HD Engineering & Design

Project Address: 1916 NE PARK RIDGE DR, LEES SUMMIT, MO 64064

Our firm has been asked to make structural clarifications to the plans of the house to be built at the address listed above. During the permit review process the AHJ has questioned items. Below is a list of our recommendations along with the corresponding city item.

STRUCTURAL REVIEW
HD ENGINEERING & DESIGN
HD: 43276 DATE: 2/25/2022

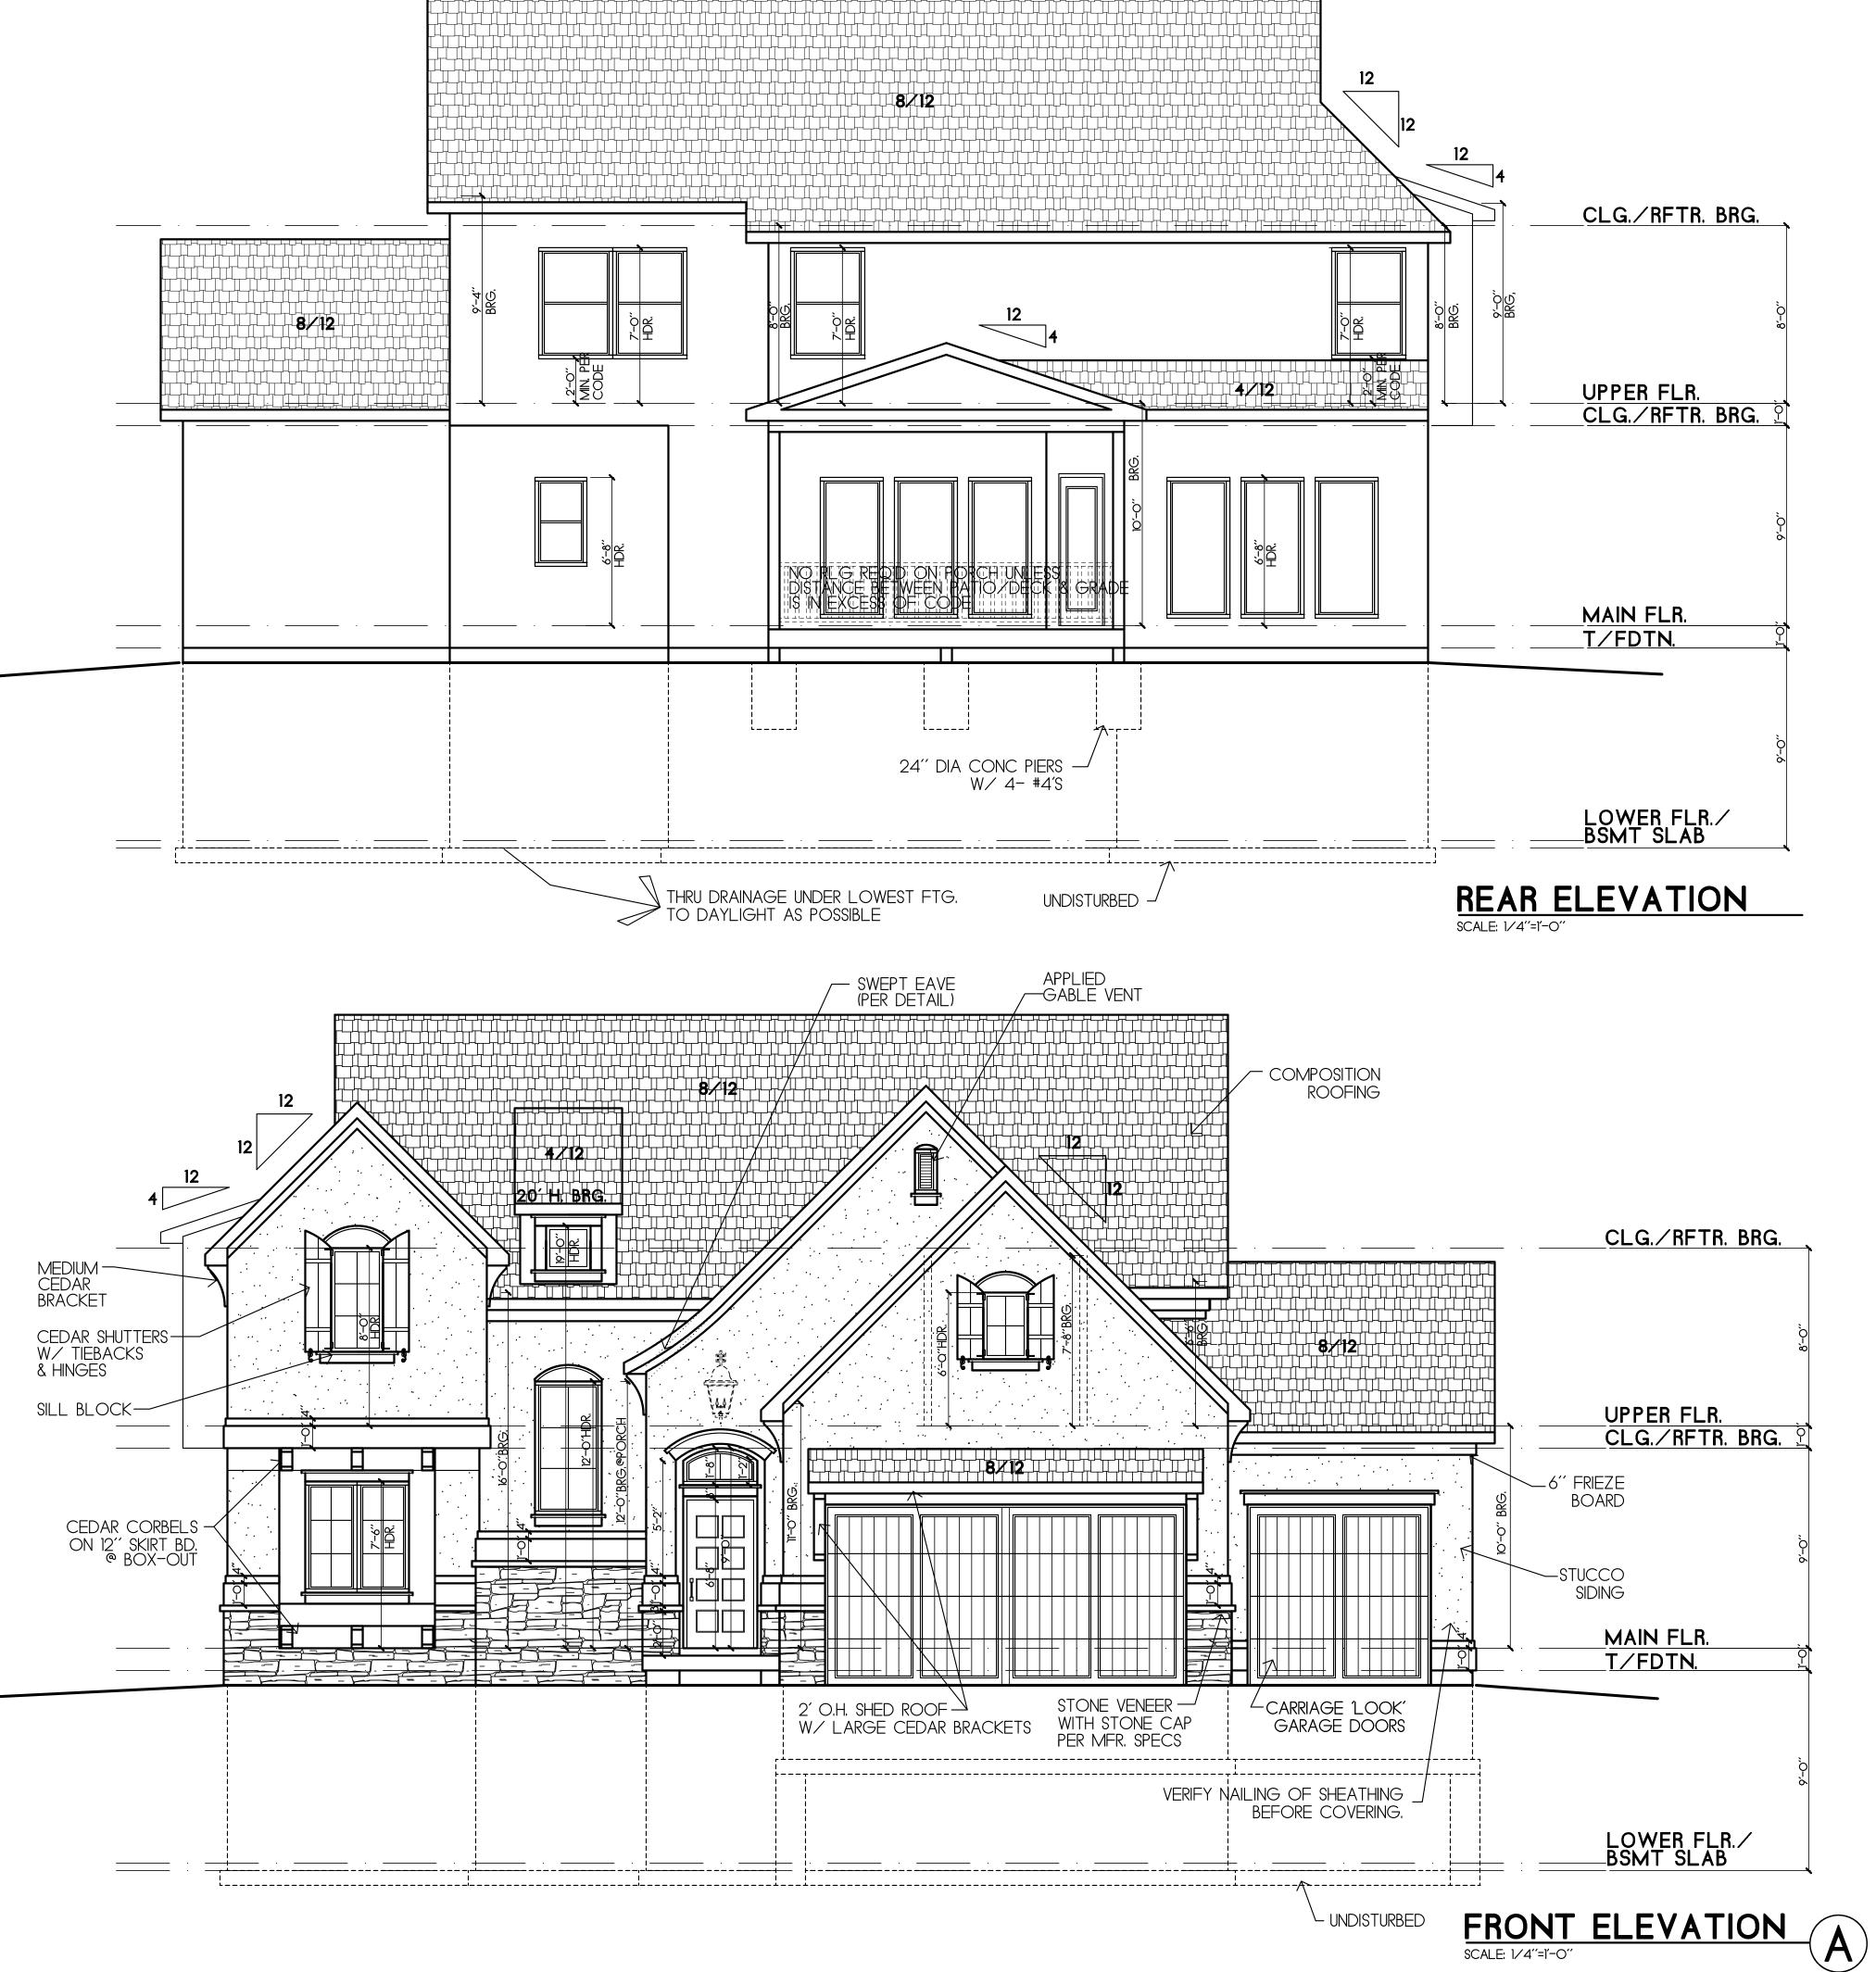
1. Provide size, spacing, species and grade of dimensional floor joists.

The plan has been revised to show #2 DFL 2X10 floor joists, see clouded revised floor plans.
